Golden Glades Multimodal Transportation Facility Feasibility Study Final Report

March 1994

STEERING COMMITTEE EVALUATIONS OF ALTERNATIVE CONCEPTUAL LAYOUTS GOLDEN GLADES MULTIMODAL TRANSPORTATION FACILITY

The following are comments received from members of the steering committee on the Golden Glades Multimodal Facility Feasibility Study, and the consultant's responses to them. Steering committee members were given sketches of three alternative layouts of terminal, parking and vehicle circulation on the Golden Glades park and ride lot, and asked for their opinions regarding strengths and weakness of each alternative scheme. The consultant appreciates both the promptness of the responses from the committee members, and the expert insight which detected the flaws and advantages in each scheme.

FIGURE 3
SCHEME A - PHASE 1

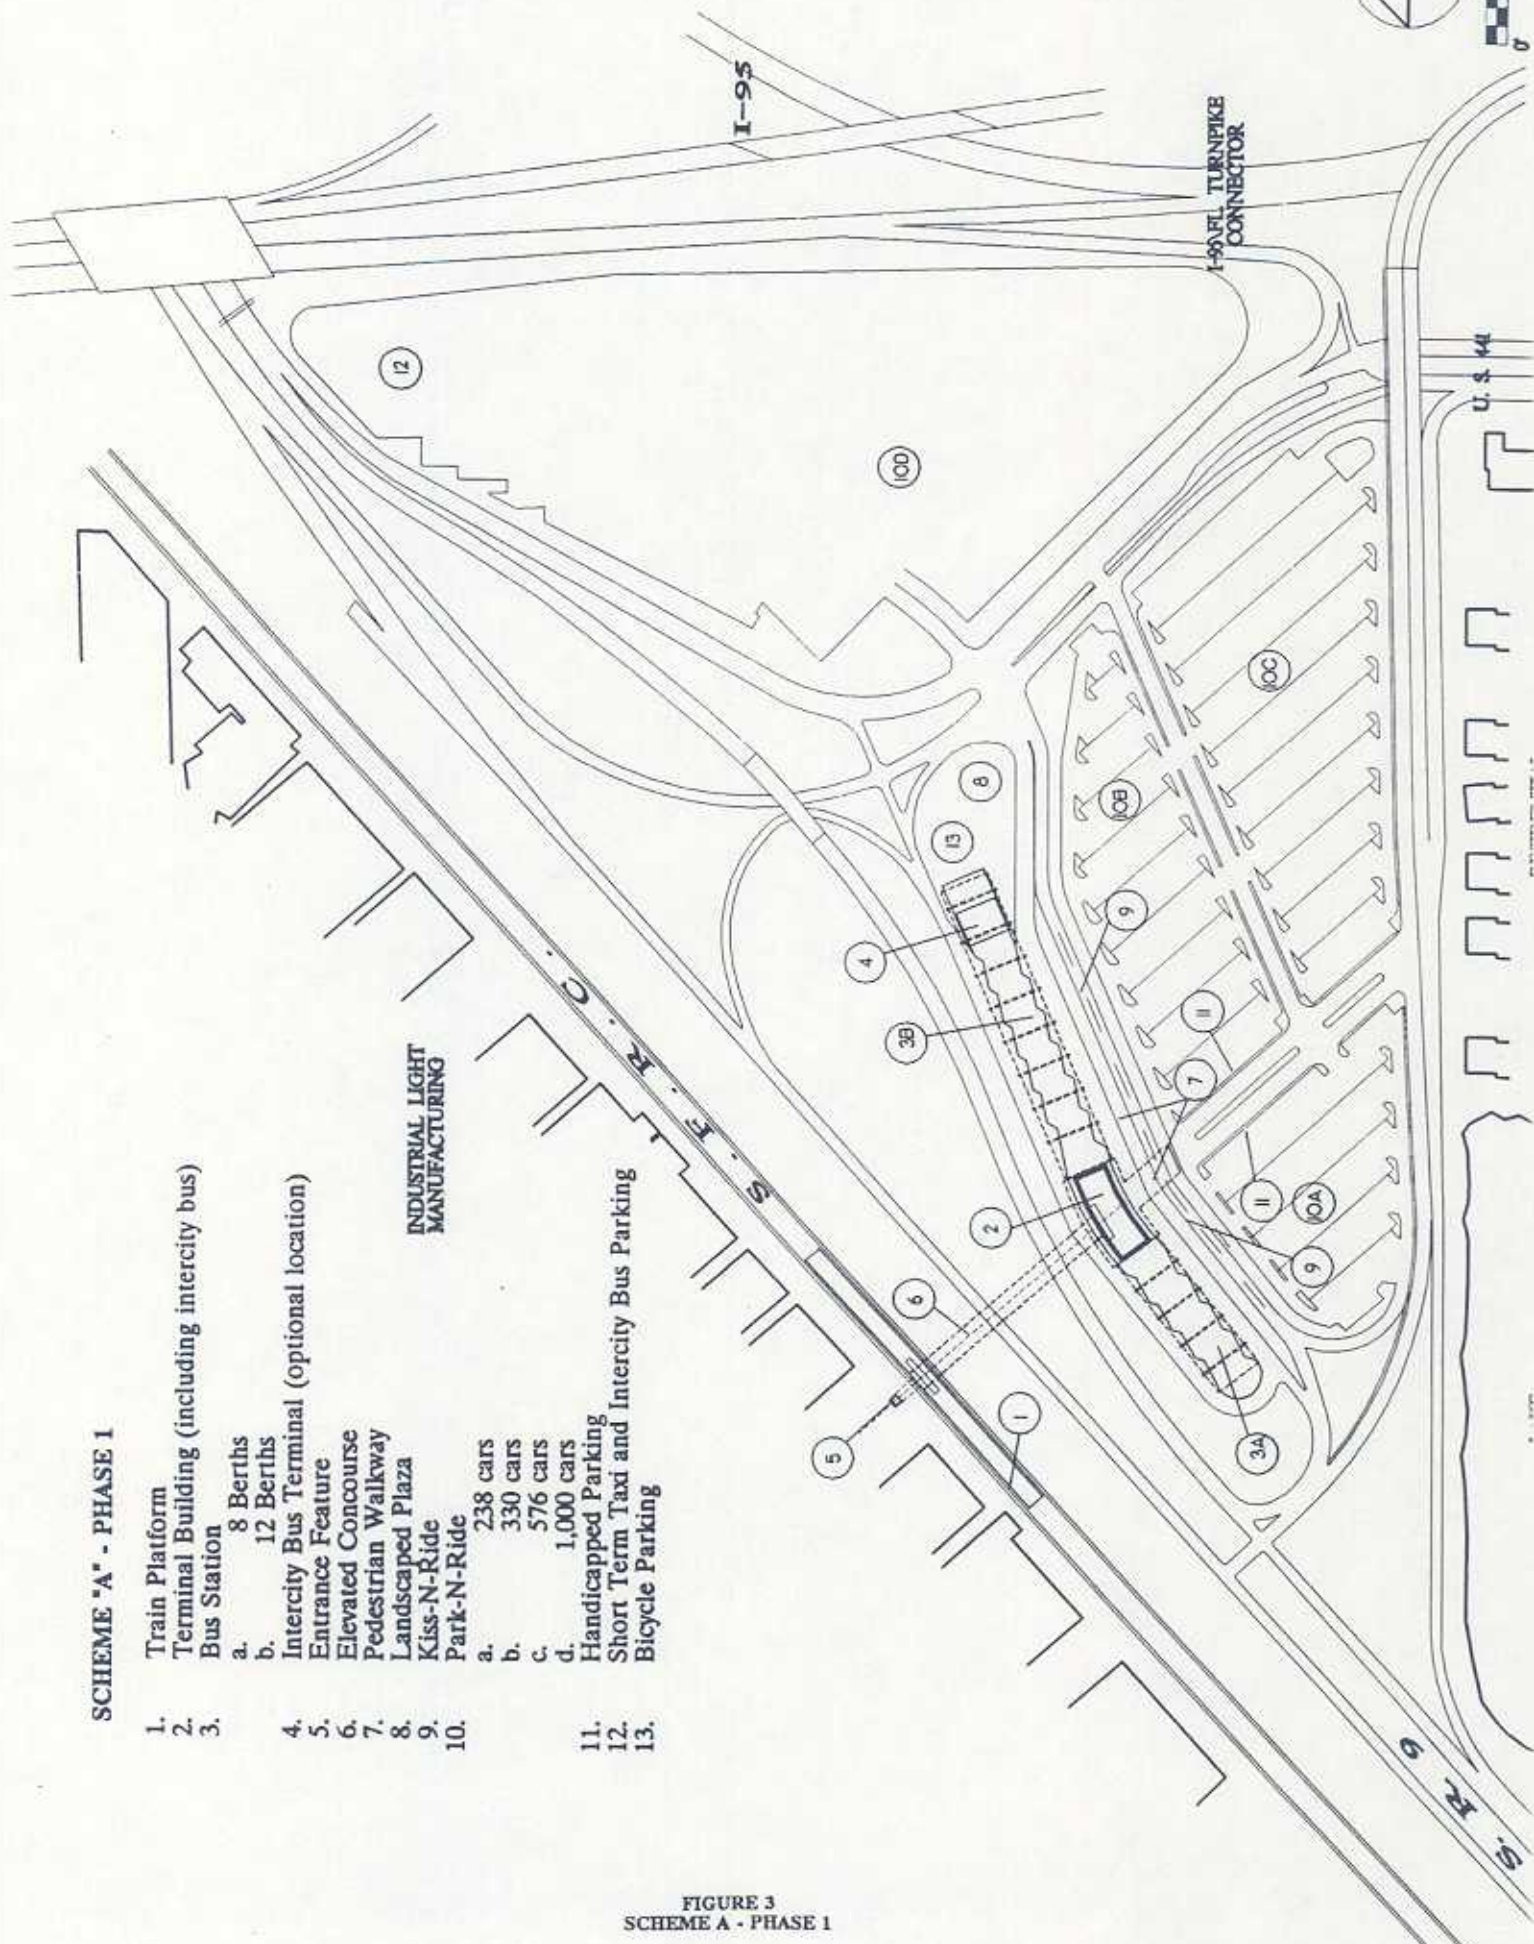
Scheme A:

Where is the Kiss and Ride located?

Identify Pedestrian Walkways (include more walkways)

How is I-95 Express Bus Circulation accomplished?

Separation between driveways into the parking area shown to be 200'. Desired distance S/B is 350'.

How is SR 9 inbound circulation accomplished?

Include circulation patterns for SR 9, I-95, 167 St., etc. for the Park and Ride circulation diagram.

The pointer for Kiss and Ride, feature 9, was inadvertently omitted. It should point to the lane with a dashed line, parallel to the bus lanes. (Also shows on KNR circulation plan.)

Will comply.

95 Express circulation will be shown more clearly on the final alternative. It uses the exit ramps to/from I-95, and circles the bus platform clockwise, travelling between the ramps and platform on the south perimeter of the PNR lot.

The plan is being revised to have only one entrance off US 441.

Beginning at the SW corner of the site, it travels east to the I-95 ramps, turns left under the ramps (same as now), and travels to the terminal or the PNR lot on a perimeter road running NW parallel to US 441.

Will comply.

FIGURE 10
SCHEME B - PHASE 1

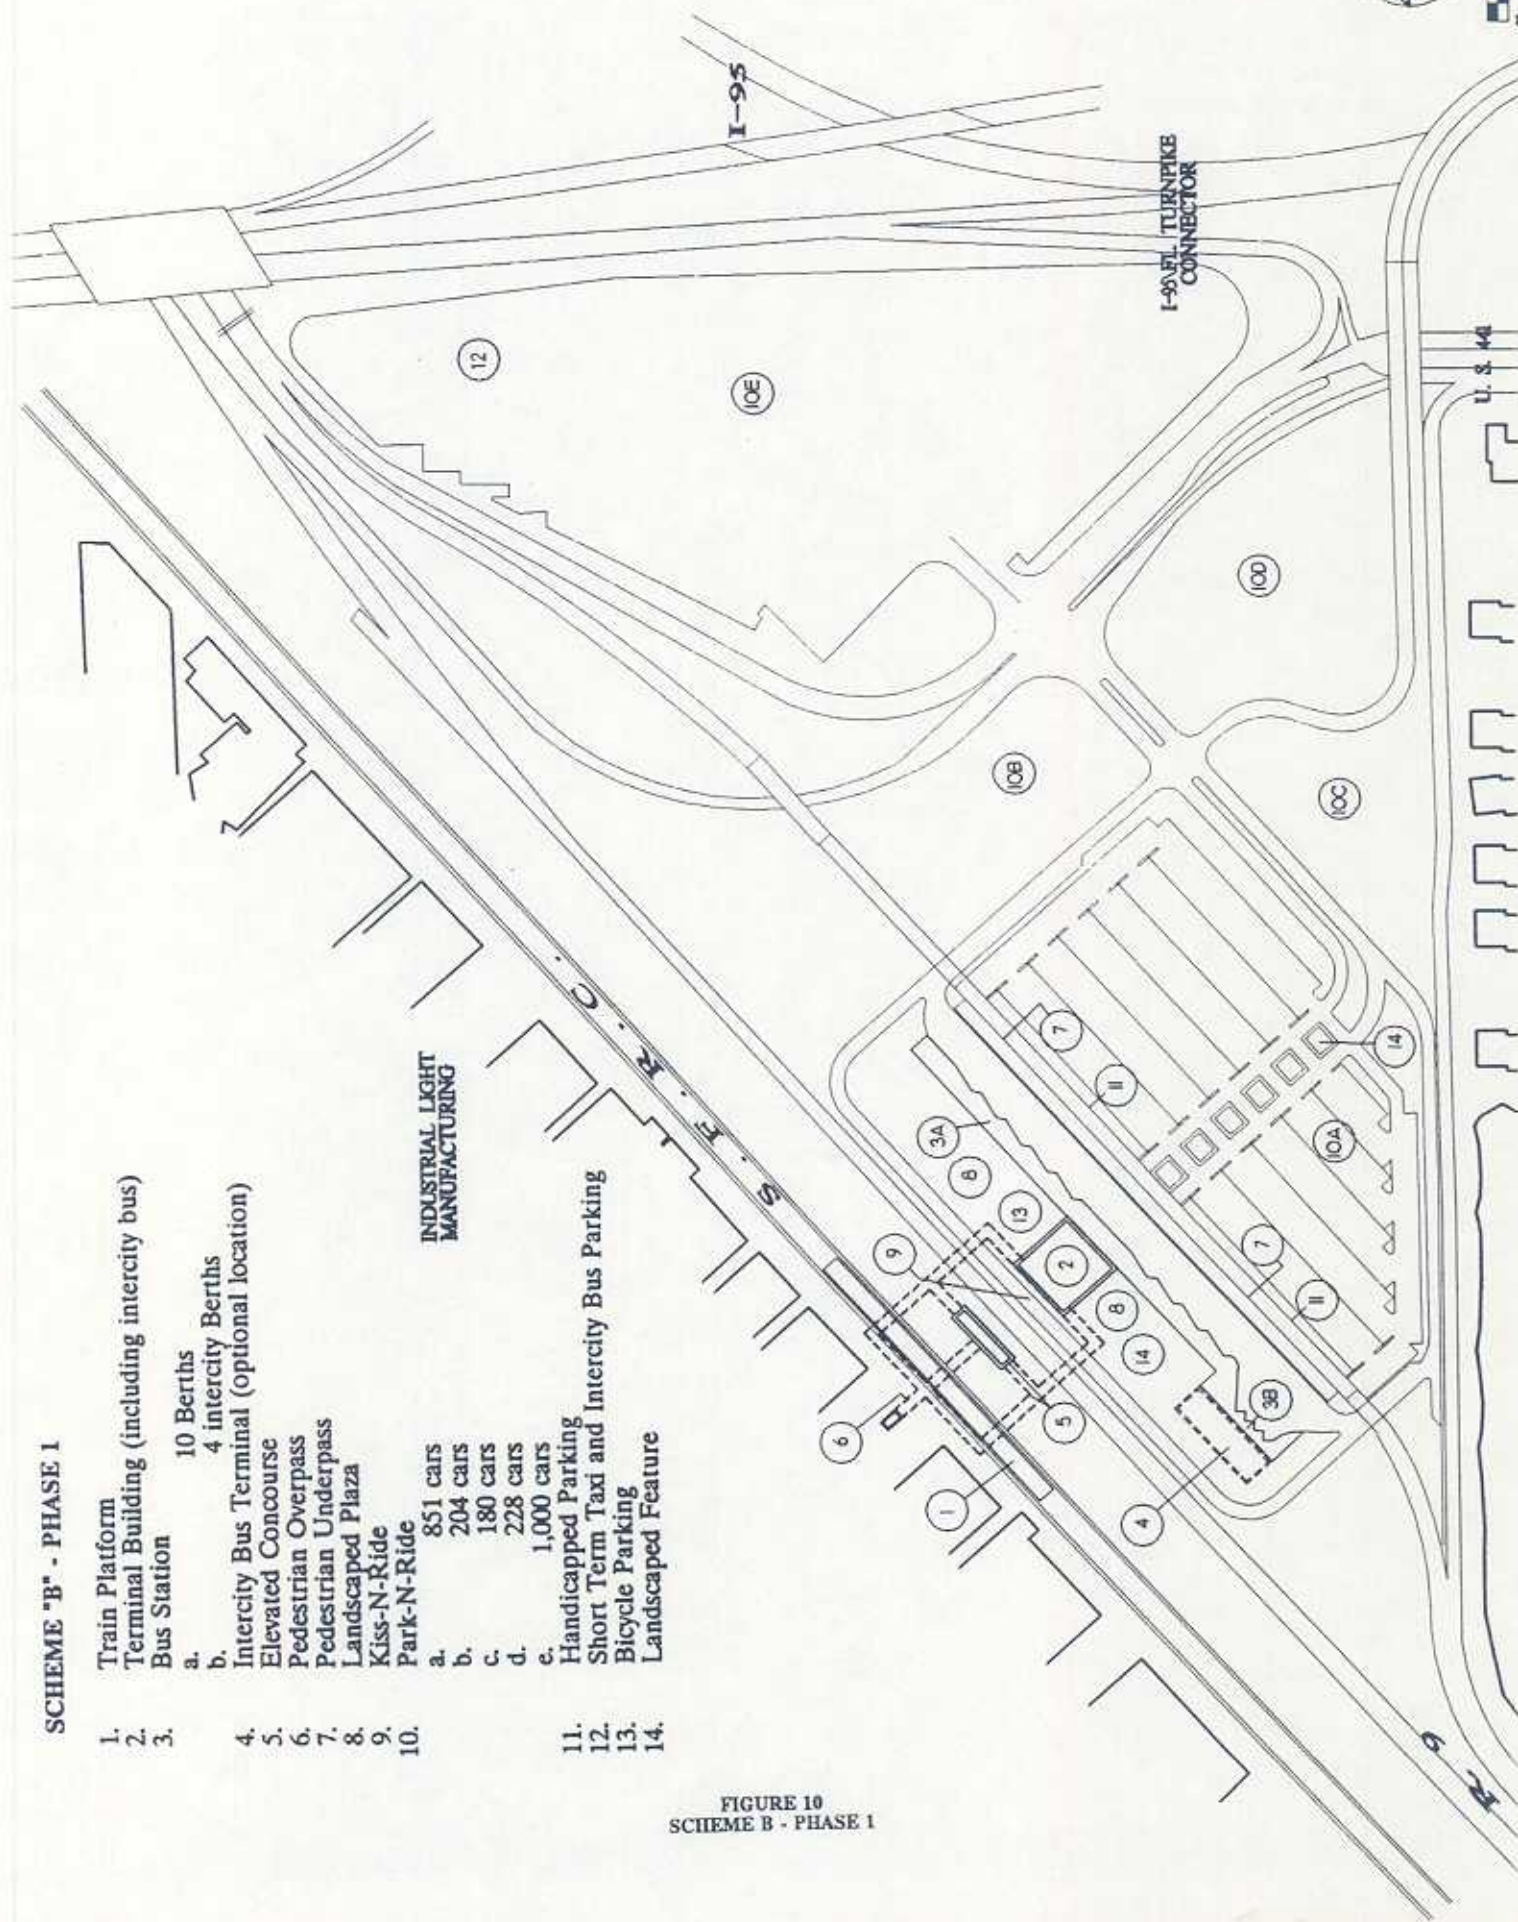
Scheme B:

Where is the Kiss and Ride?

Major conflicts between SR 9 and internal circulation.

Reverse curve on I-95 express ramps. Need to coordinate with bus operations.

Bus and Car Traffic is not separated. Prefer not to mix the two traffic patterns.

Scheme only shows one entrance/exit.

Between the terminal (2) and the NB lanes of SR 9. It should be labelled 9. (Visible on KNR circulation plan.)

The circulation plan in the preferred alternative will resolve this.

Ditto.

This is being revised.

Entrances/exits to and from SR 9 and I-95 will be made more obvious.

FIGURE 17
SCHEME C - PHASE 1

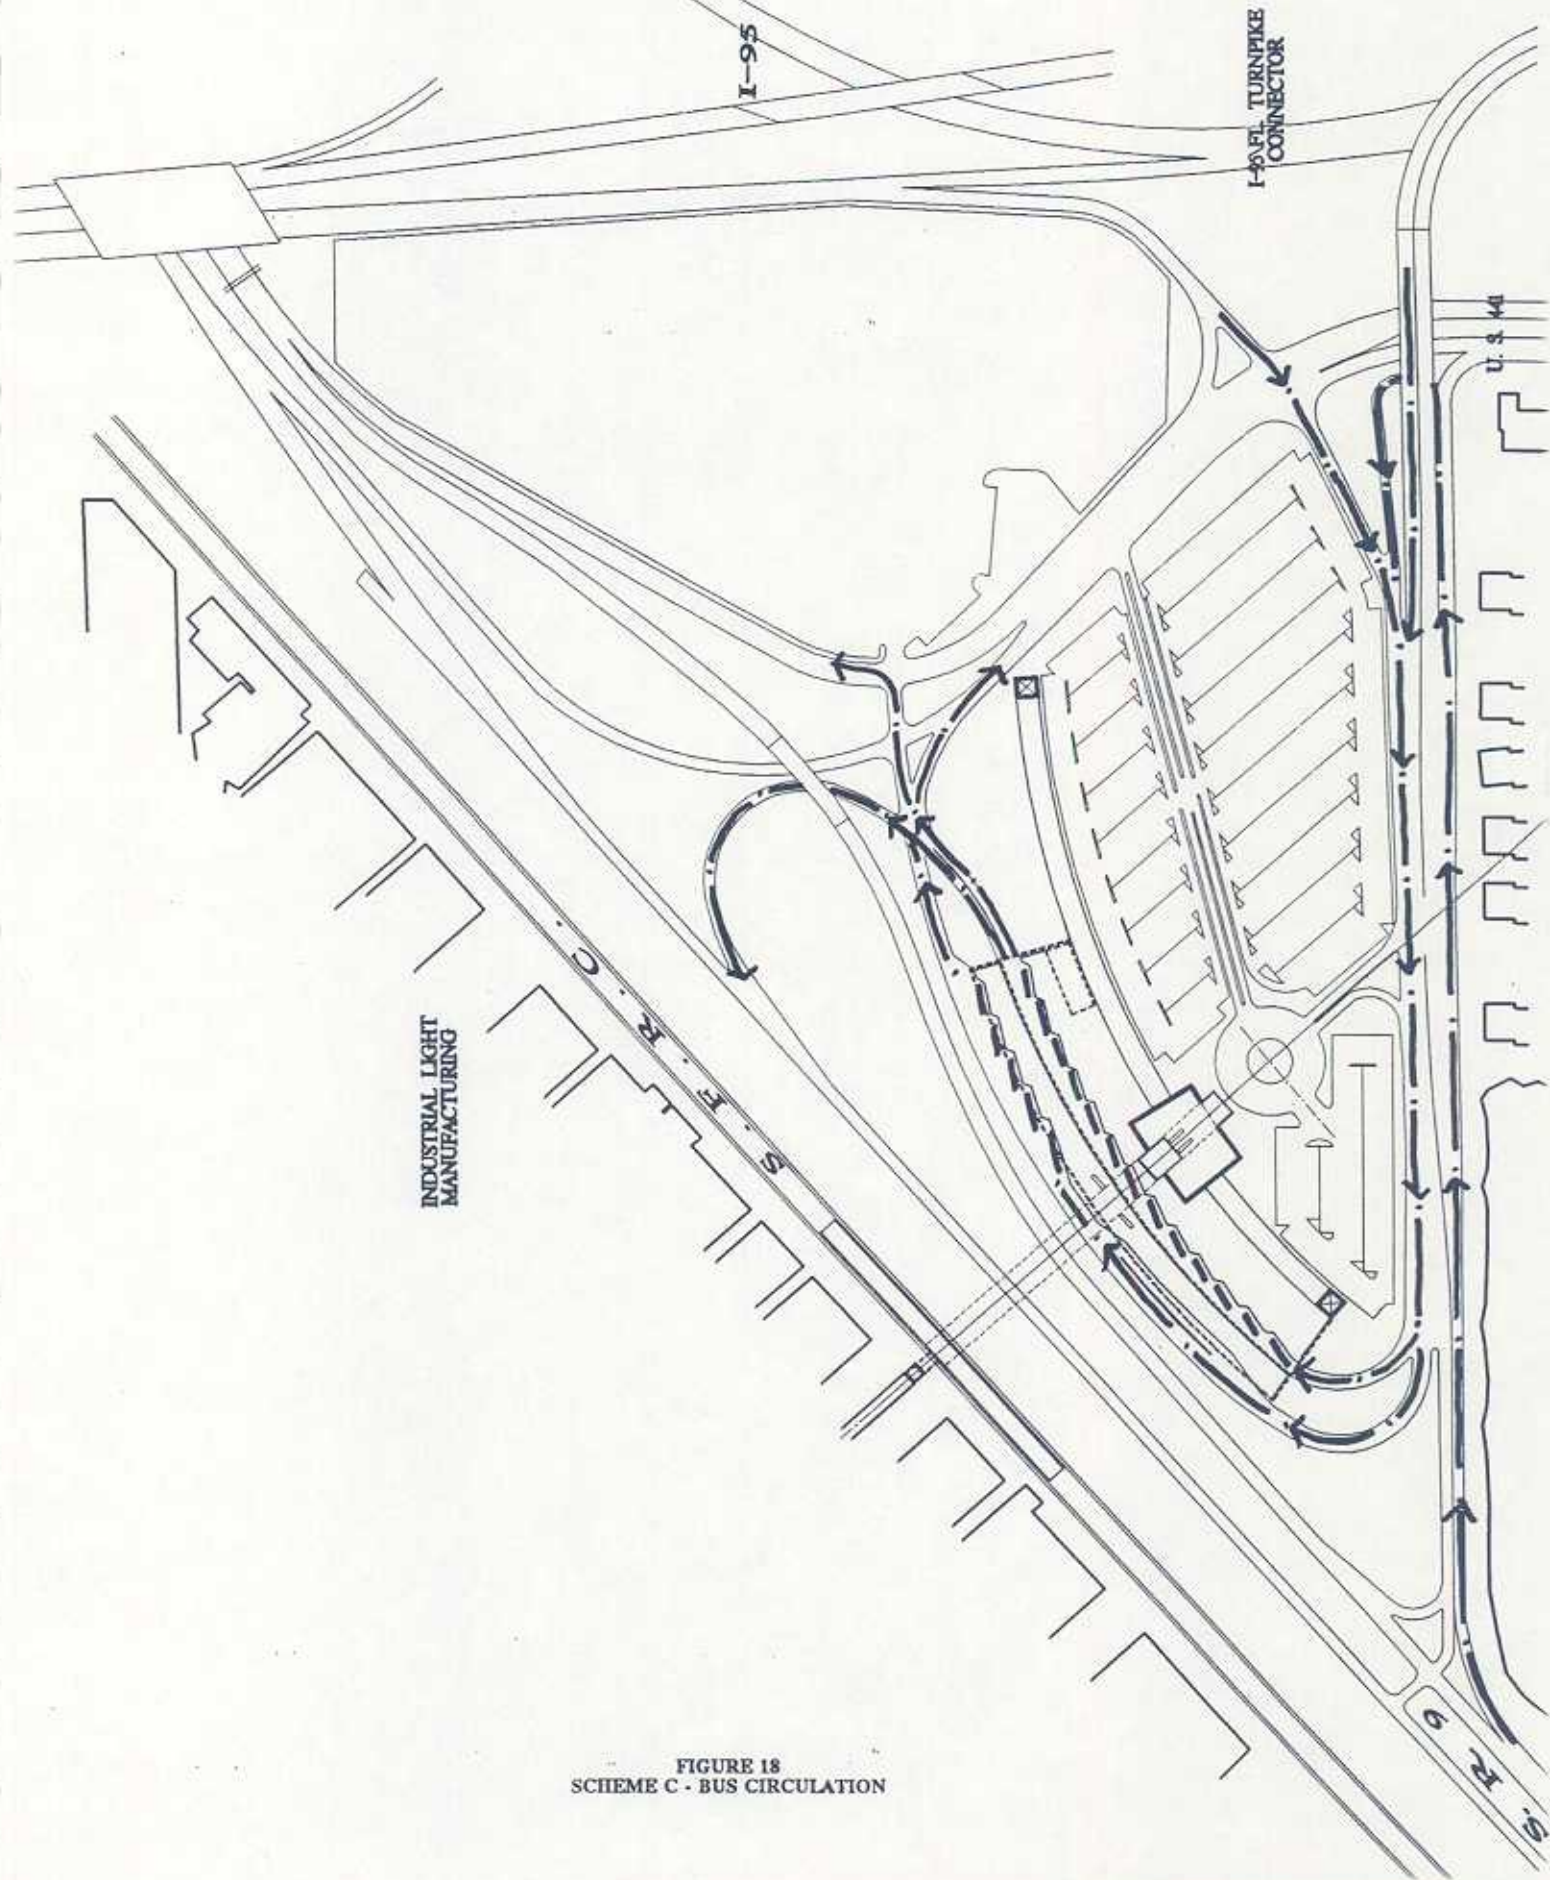
Scheme C:

Distance from terminal building to TriRail Station is large (approx. 400'-500').

Express bus access onto I-95 S.B.?

How many bus bays are needed?

What about grade separation of SR 9.

See first comment on page 1.

Will be revised and shown more clearly.

MDTA should answer this. The four which currently serve the Golden Glades PNR appear to be adequate now. In all schemes, bus bays can be added as needed.

A median crossover on SR 9 has recently been added near the SW corner of the PNR, at a location which showed signs of illegal crossovers. Although SR 9 is not a fully grade-separated roadway at this location, we have shown a possible arrangement to improve the grade-separation characteristics by putting a new ramp under the existing bridge. This ramp will be labelled "Possible future ramp."
